# Access Compliance Report

## Public Rights-of-Way

### (Curb Ramps)

Intersection ID: 26318	Main Street: BEAUCATCHER_LN	Cross Street: INDIA_WILKES_PL	Location: NW
ADA ID: ED95E9345136	Ramp Type: Perp	Initial Pass/Fail: Fail	Overall Compliance: No
Severity Score: 33.75			
Codes/Mitigation Info/Possible Solution		Field Measurements/Component Compliance

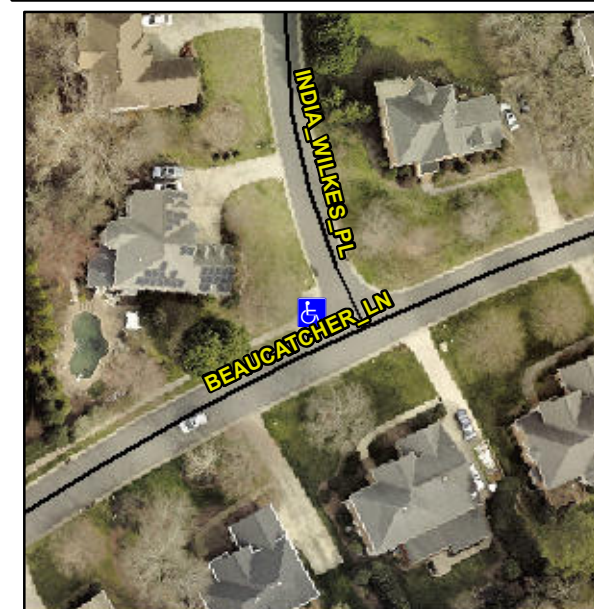
**Not Found, R304.5.1, R304.5.3**

Compliance	Description	Data	Compliance	Description	Data
N/A	Ramp Length (in)	93.0	Yes	Ramp Slope (%)	5.5
No	Ramp Width (in)	38.0	No	Ramp XSlope (%)	9.3
N/A	Flare Type LT	N/A	N/A	Flare Type RT	N/A
N/A	Flare Slope LT (%)	N/A	N/A	Flare Slope RT (%)	N/A
N/A	Flare Traversable LT?	N/A	N/A	Flare Traversable RT?	N/A
N/A	Landing Length (in)	N/A	N/A	DWS Provided?	N/A
N/A	Landing Width (in)	N/A	N/A	DWS Contrast?	N/A
N/A	Landing Slope (%)	N/A	N/A	DWS Length (in)	N/A
N/A	Landing X Slope (%)	N/A	N/A	DWS Full Width?	N/A
N/A	Landing Curb? (Y/N)	N/A	N/A	DWS Offset (in)	N/A
N/A	Shared Landing?	N/A			
N/A	Gutter Ponding?	N/A	N/A	Gutter Slope (%)	N/A
N/A	Gutter Lip Ht (in)	N/A	N/A	Gutter X Slope (%)	N/A
N/A	Painted X Walk1?	No	N/A	Painted X Walk2?	N/A
	X Walk 1 Direction	To S		X Walk 2 Direction	N/A
N/A	X Walk 1 Width (in)	N/A	N/A	X Walk 2 Width (in)	N/A
	X Walk 1 Slope (%)	8.7		X Walk 2 Slope (%)	N/A
	X Walk 1 X Slope (%)	6.4		X Walk 2 X Slope (%)	N/A

**Remove & Replace Entire Ramp.**
